ITEM FOR ENVIRONMENTAL COMMISSION AGENDA

West Harbour Marina

SP-2018-0221C

REQUEST:

1. Cofferdam Locations for Heritage Tree Protection	p. 6
2. Table of Required and Proposed Mitigation Plantings	p. 7

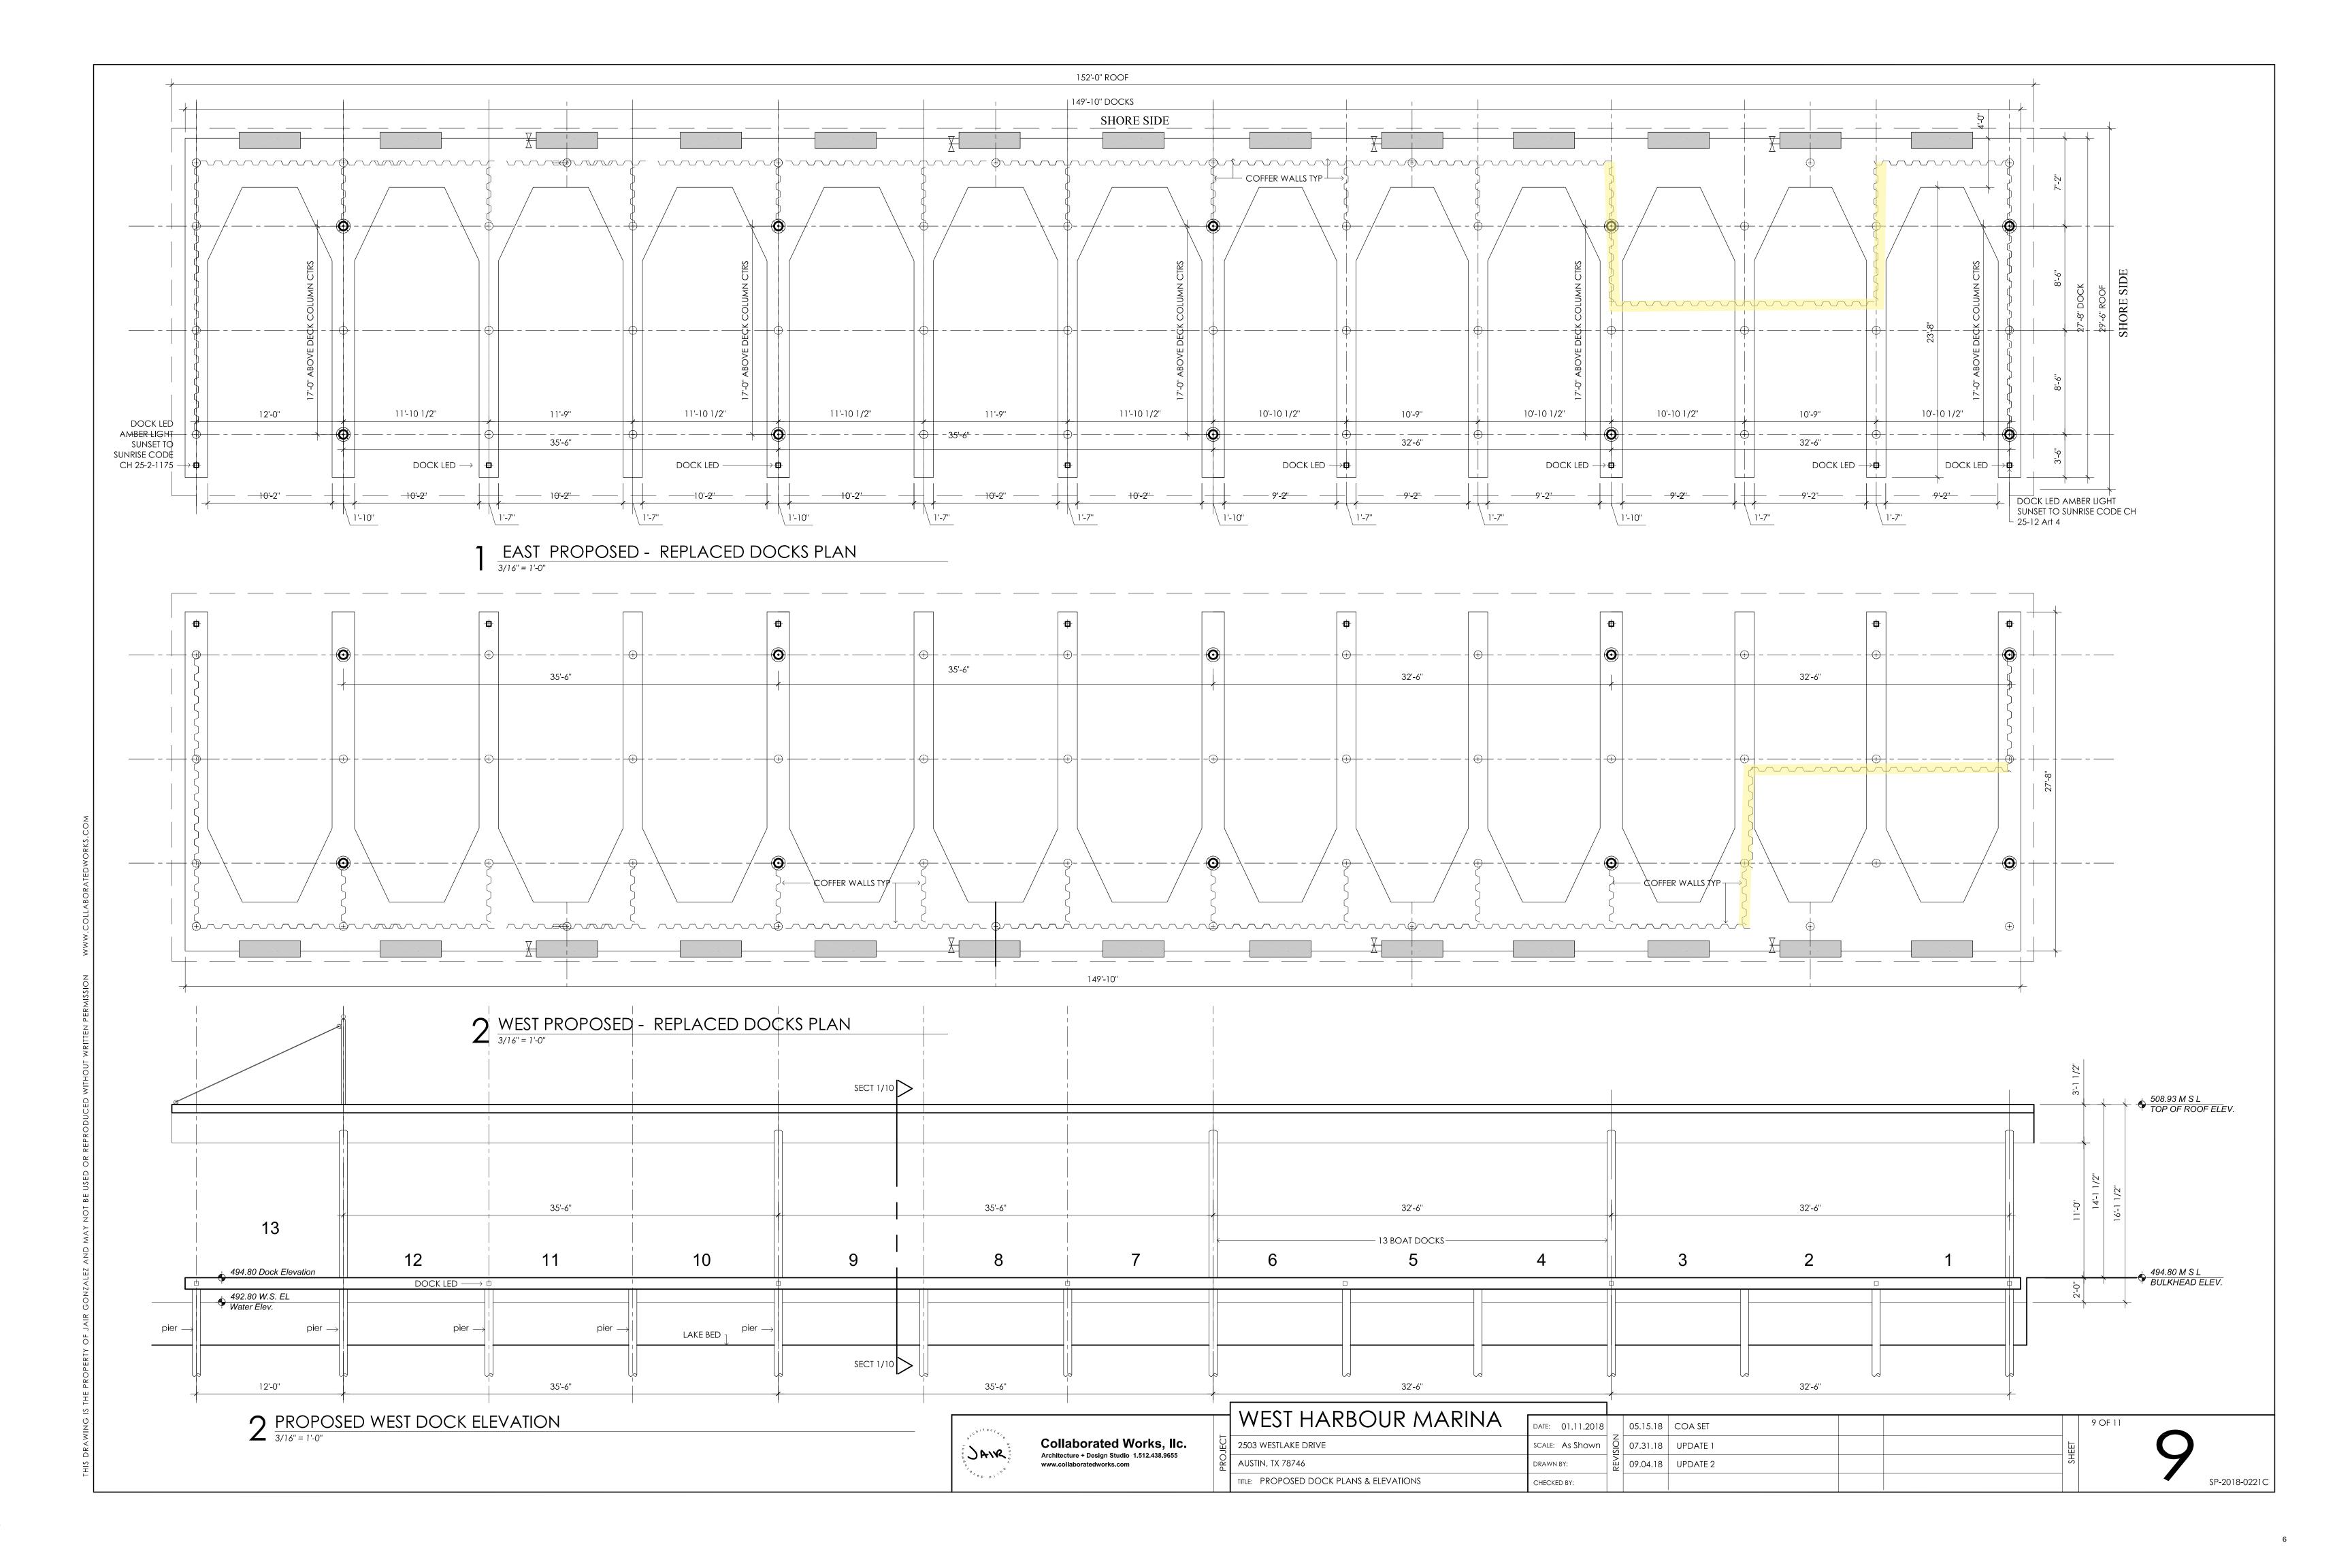
Staff recommends the following conditions: 1) install cofferdams before beginning dredging on the 4 slips adjacent to Heritage tree roots; 2) provide additional mitigation, beyond the requirements, for wetlands (32 additional plants), riparian restoration (7 additional 609S plants), and tree replacement (32 additional

Staff determination is that the findings of fact have been met. Staff recommends
the following conditions: 1) install cofferdams
before beginning dredging on the 4 slips adjacent to Heritage tree roots; 2) provide
additional mitigation, beyond the requirements, for wetlands (32 additional plants),
riparian restoration (7 additional 609S plants), and tree replacement (32 additional
inches).

TOTAL REQUIRED WETLAND PLANTS = 660 LF (BULKHEAD) / 3 + 75 (WETLAND)= 295 PLANTS 327 WETLAND PLANTS PROPOSED 32 more plants provided than required

TOTAL 609S SHRUBS REQUIRED = 92 SHRUBS
99 SHRUBS ARE PROPOSED
TOTAL 609S UNDERSTORY TREES REQUIRED = 19 TREES
19 UNDERSTORY TREES ARE PROPOSED
TOTAL 609S SHADE TREES REQUIRED = 19 TREES
19 TREES ARE PROPOSED. 7 more plants provided than required

TOTAL 609S PLANTS REQUIRED = 130 PLANTS, 137 PLANTS PROPOSED Tree mitigation required = 82". 114" provided. That's 32" more than required.
